## **DANIEL DINKINS SUBDIVISION**

APPLICATION NUMBER 10 DATE April 5, 2007

## DETAIL SITE PLAN

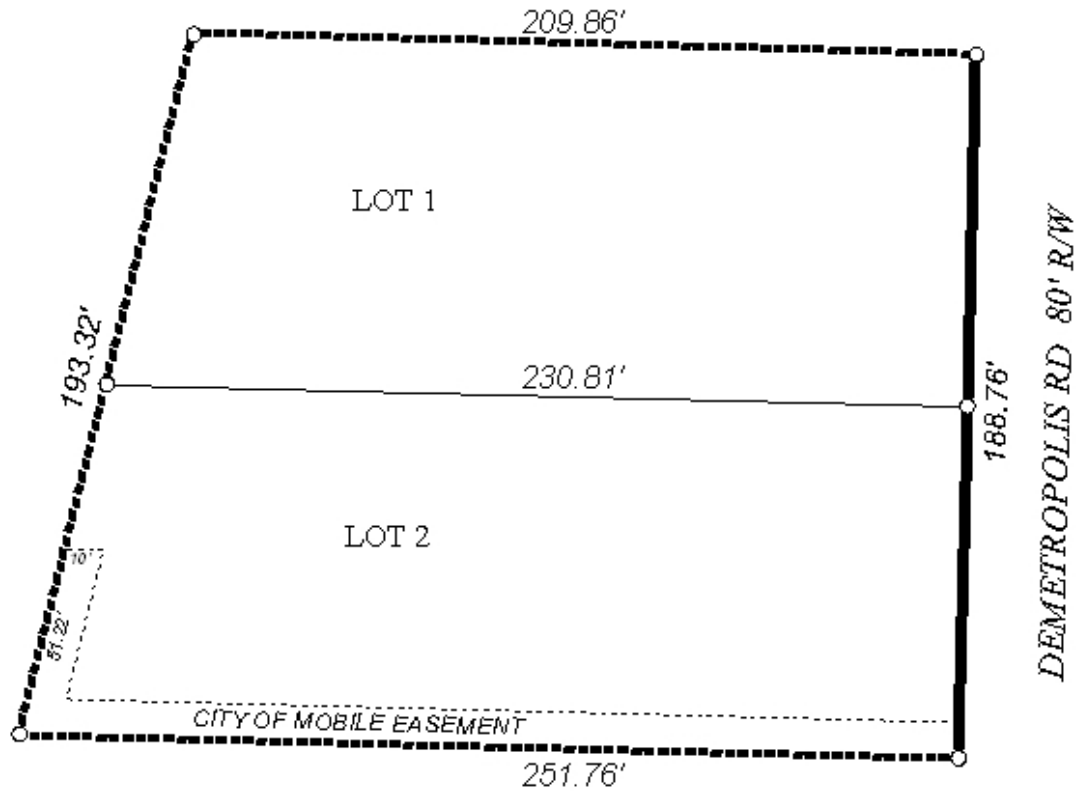
There was a second issue identified during the previous application as well, namely that the "City of Mobile Easement" depicted on the plat is, in fact, owned by the City of Mobile. Documentation provided by the survey company for the previous application, subsequently verified by the Real Estate Department, shows that the "easement" was deeded to the City in 1978. The plat should be revised to exclude the City-owned property.

The site fronts onto North Demetropolis Road, a minor street with adequate right-of-way. While North Demetropolis Road is a minor street, access management is a concern. Each proposed lot should be limited to one curb-cut each, with the size, design and location to be approved by Traffic Engineering and comply with AASHTO standards.

The 25-foot minimum building setback line, required in Section V.D.9., is not shown for the subdivision, but would be required on the final plat, if approved.

- 1) revision of the plat and legal description to exclude the "City of Mobile Easement;"
- 2) depiction of the 25-foot minimum building setback line;
- 3) placement of a note on the plat stating that each lot is limited to one curb-cut each onto Demetropolis Road, with the size, design and location to be approved by Traffic Engineering and conform to AASHTO standards;
- 4) labeling of each lot with its size in square feet, or provision of a table on the plat with the same information; and
- 5) full compliance with all other municipal codes and ordinances.
